Addendum #1

Date: November 19, 2021
Project: **Offsite Waterline Supply**
Lukachukai Community School Replacement
Location: Indian Route 12
Lukachukai, AZ 86507

RE: LCS & NHA Offsite Waterline, Lukachukai AZ – NTUA-HQ Review @ 'Pre-Final' Submittal

SHEET NO.
G-01
OF

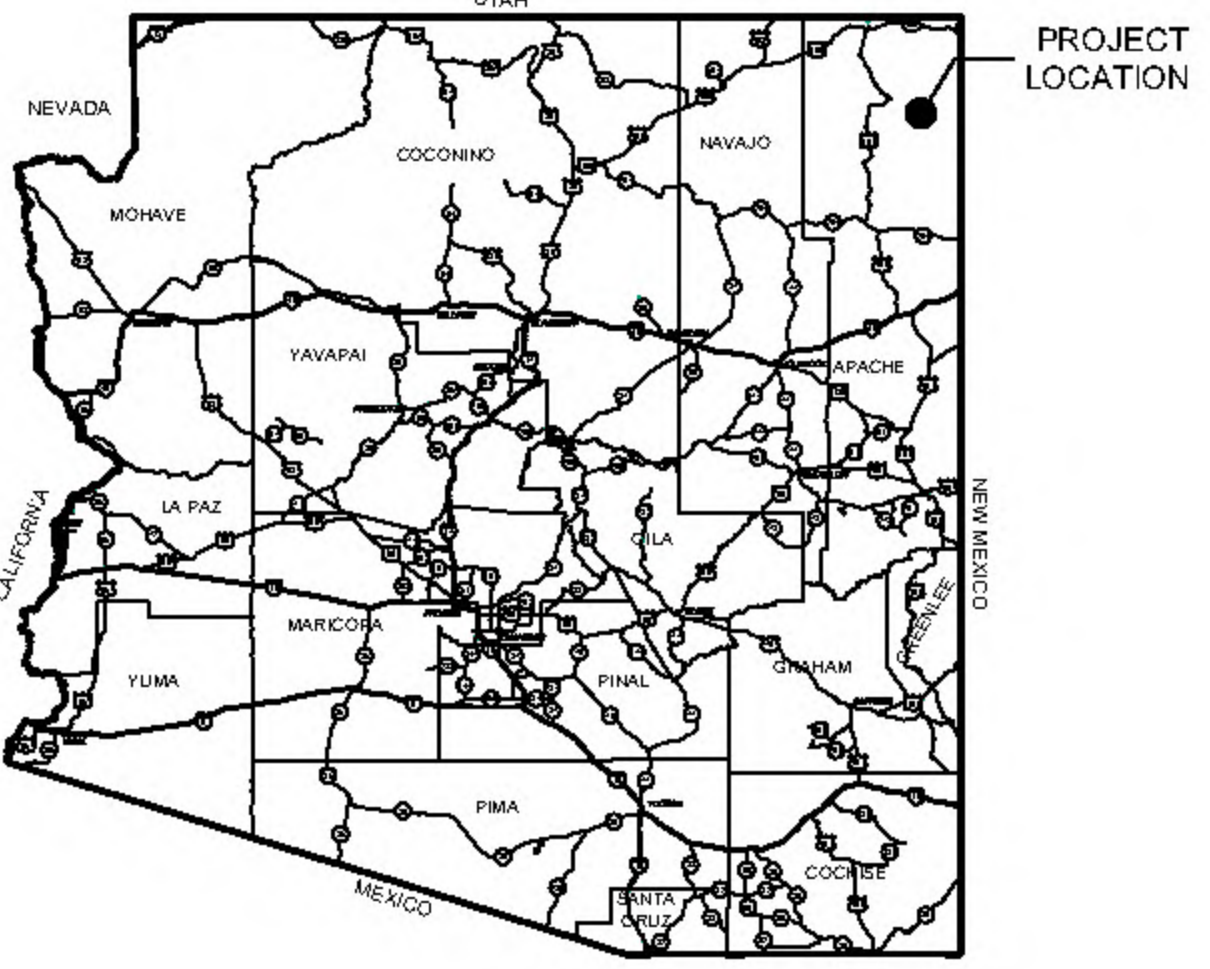
1. Title: Update the project title to include reference of the NHA project as shown on the cover sheet.

HEET NO. **C-01**  OF

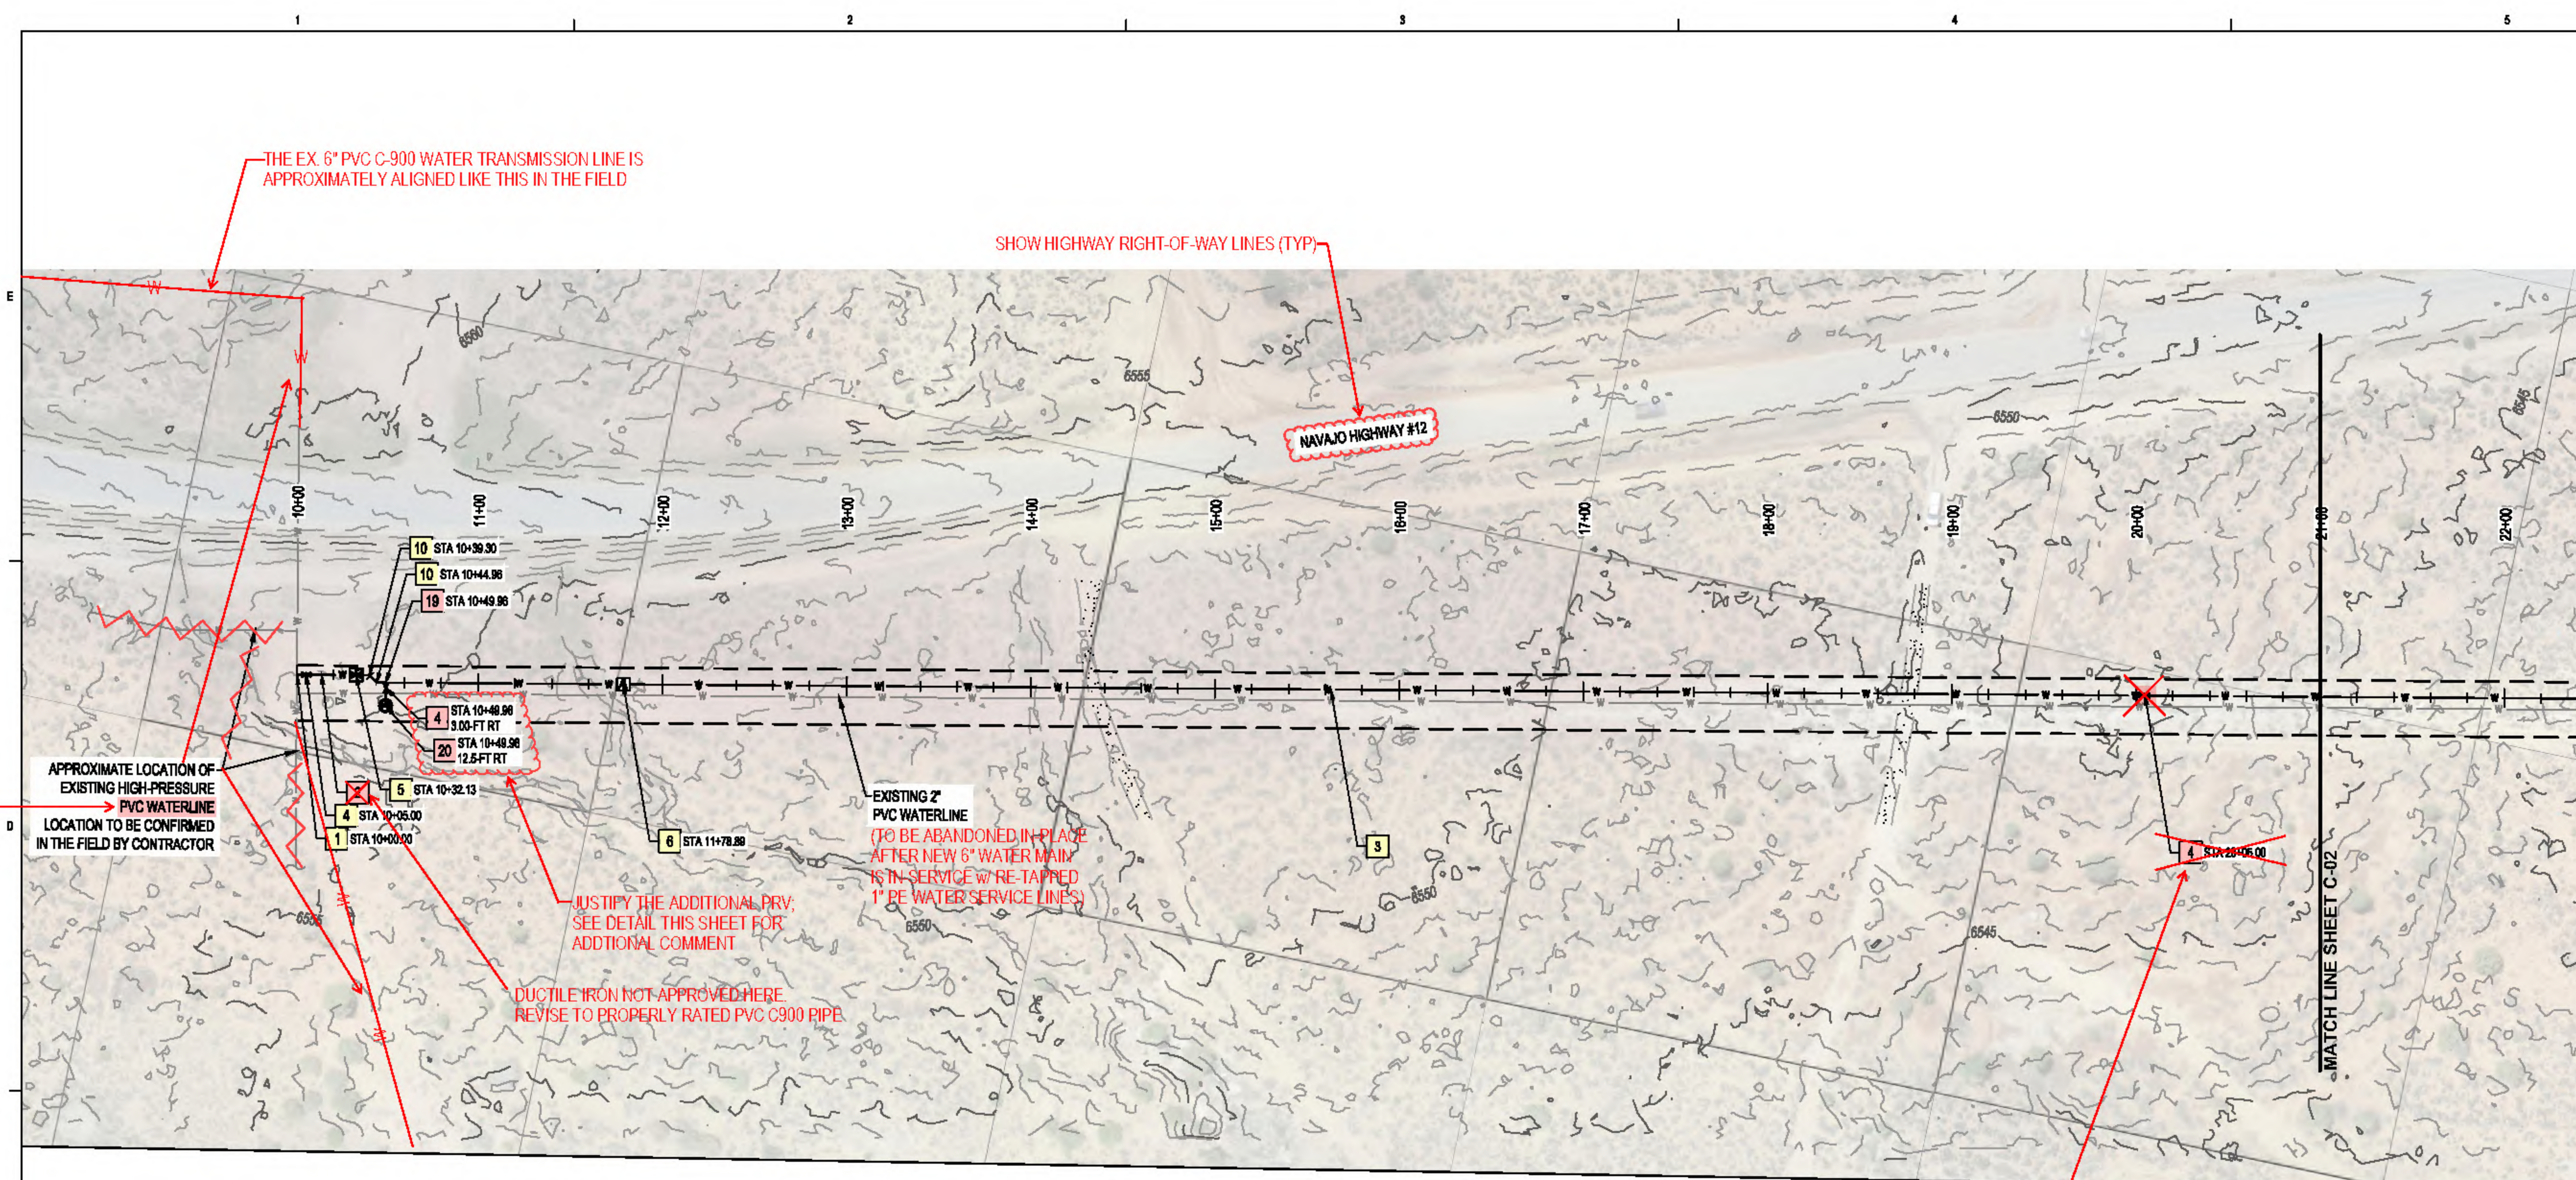
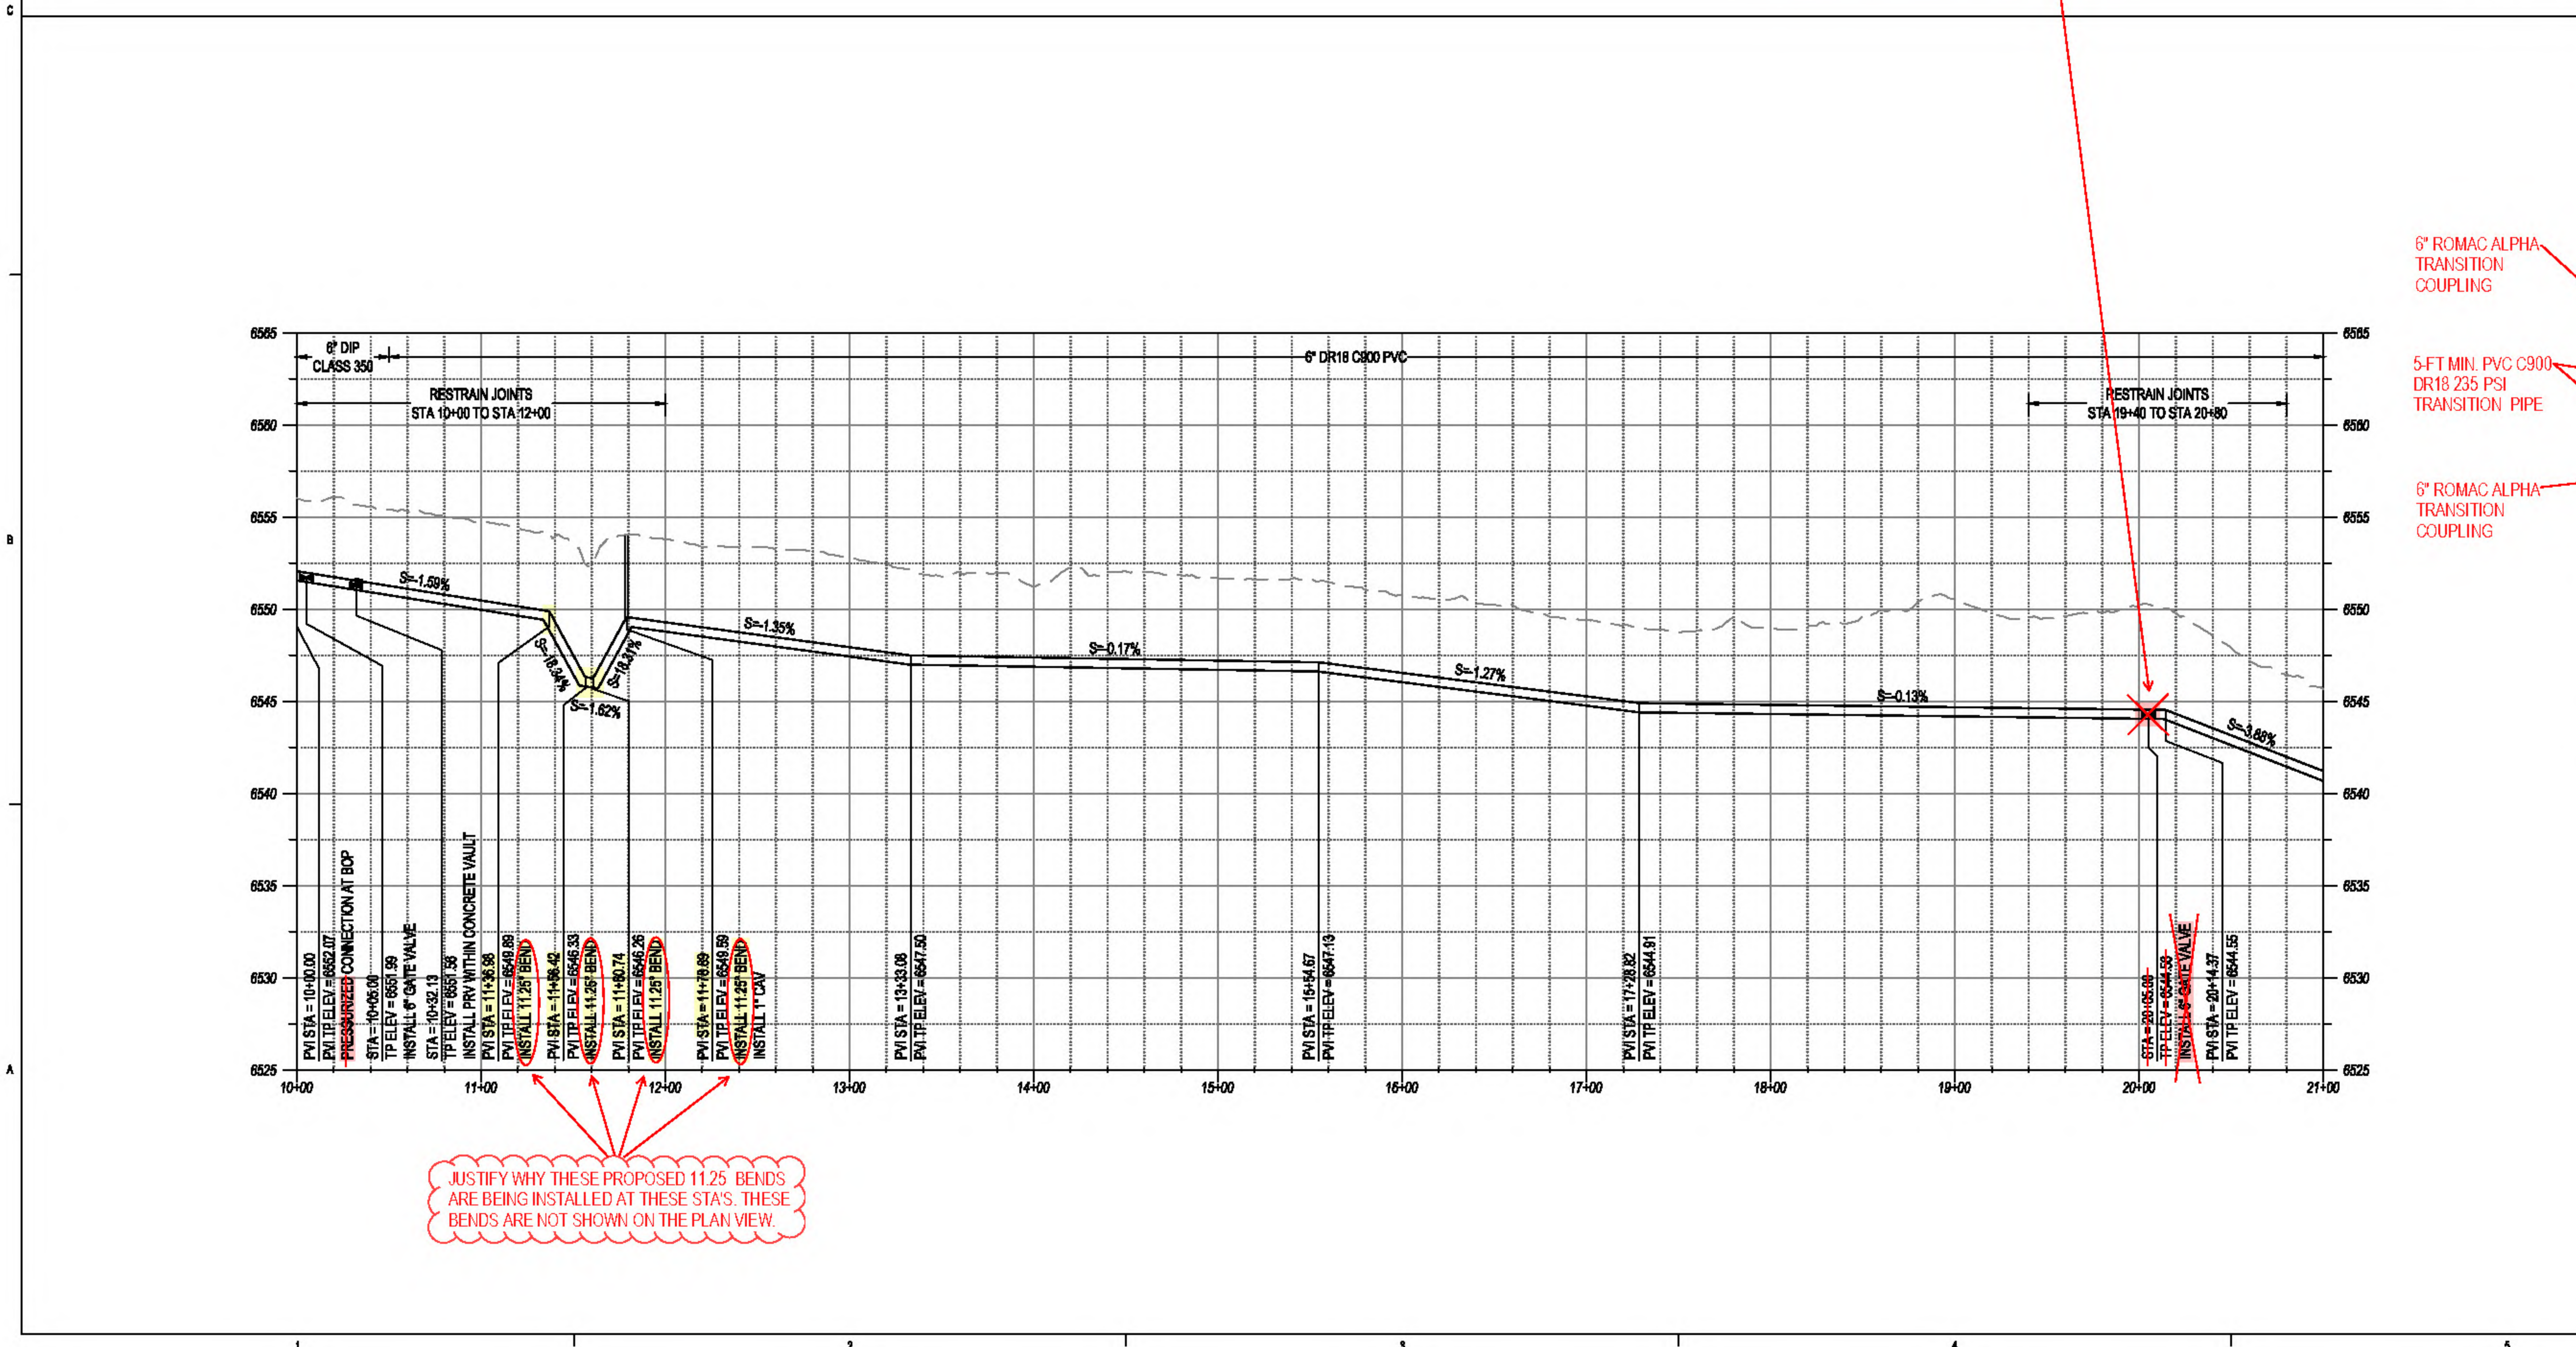
1. Ex. 6" PVC C900 W/L: Adjust/fix the ex. 6" transmission line alignment as shown on the plan sheet.
2. Show the required PRV data table on this Sheet C-01. The table shall include the PRV name/number, the size(s) which include the bypass, and the inlet and outlet settings.

3. Plan Keyed Notes #4 & #20: Justify the additional pressure relief valve & vault. (Surge Relief Valve Station per Dwg. 2353 on Sheet D-04) See Waterline Connection Detail review comments below.

4. Ex. 2" PVC W/L label: Also callout to be 'abandoned in-place' as shown on the plan sheet.
5. Sta. 20+05.00 (Proposed in-line 6" Gate Valve): Remove this proposed G.V. as it will not be required per IHS design standard for gate valve installations at 5,280-ft (1 mi.) segment increments or a change in design grade elevation of more than >50-ft vertically, or major alignment P.I./bend areas.

6. Keyed Notes: Make corrections to the key note descriptions as shown on the plan sheet.

1. Sta. 10+00 (Tapping Pt.): Tapping saddle not approved. Utilize 6" Tee, DI, MJ, w/ Thrust Block. Hot tap not approved, the ex. 6" high-pressured transmission line must be isolated and depressurized before tapping with the new 6" tee w/ transition piping & couplings as shown on the detail comments.

2. The ex. 6" high-pressured transmission line's current dynamic/static pressures must be checked and verified. Install the appropriate pressure rated PVC C900 pipe. Ductile iron application not approved.

3. Sta. 10+49.96 (Proposed 6" PRV w/in Manhole): Justify the additional pressure relief valve & vault. (Surge Relief Valve Station per Dwg. 2353 on Sheet D-04) These facilities are not required per the planned PRV @ Sta. 10+62.13 which should suffice the high-pressure incoming flow to the new 6" PVC C900 waterline. This is not an NTUA standard. The operating District Office will not operate & maintain (O&M) this facility.

4. Edit/add the additional minor text items/labels on the detail, as shown.

1. Proposed 11.25° Bends (Sta's 11+36, 11+56, 11+60, 11+78): Justify why these proposed bends are being installed at these Sta's. These bends are not shown on the plan view. If the bends are per vertical realignments for what looks to be a minor local drainage ditch, also callout on the plan view.

2. INSTALL 6" DUCTILE IRON WATERLINE. ← A DUCTILE IRON (DI) APPLICATION NOT APPROVED HERE

3. INSTALL 6" DR18 C900 PVC WATERLINE. ← LABEL/SHOW PRESSURE/CLASS (TYP)

JUSTIFY THE ADDITIONAL PRV;
SEE DETAIL THIS SHEET FOR
ADDITIONAL COMMENT

TAPPING SADDLE NOT APPROVED.
USE 6" TEE, DI, MJ, w/ THRUST BLOCK.

THESE FACILITIES ARE NOT REQUIRED. JUSTIFY THE PROPOSAL FOR THESE ITEMS.

REMOVE THIS IN-LINE GATE VALVE:
NOT REQUIRED AT THIS LOCATION.
SEE REVIEW COMMENTS LETTER.
